## **Product Change Notification**

## Bourns® Model SRR7032, SRR7045 and PM74SH Shielded SMD Power Inductors Changes to Shield Ring and Mounting Platform

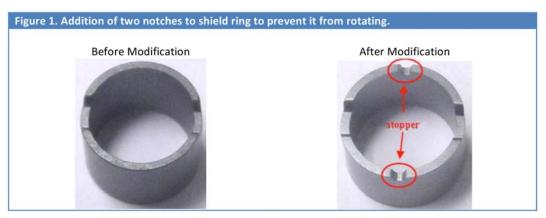
- Two notches will be added to the shield ring to act as stoppers to help prevent the shield ring from rotating during inductor assembly. (See Figure 1.)
- Two bumps will be added to the mounting platform where they interact with the notches of the shield ring to help prevent rotation during assembly. (See Figure 2.)
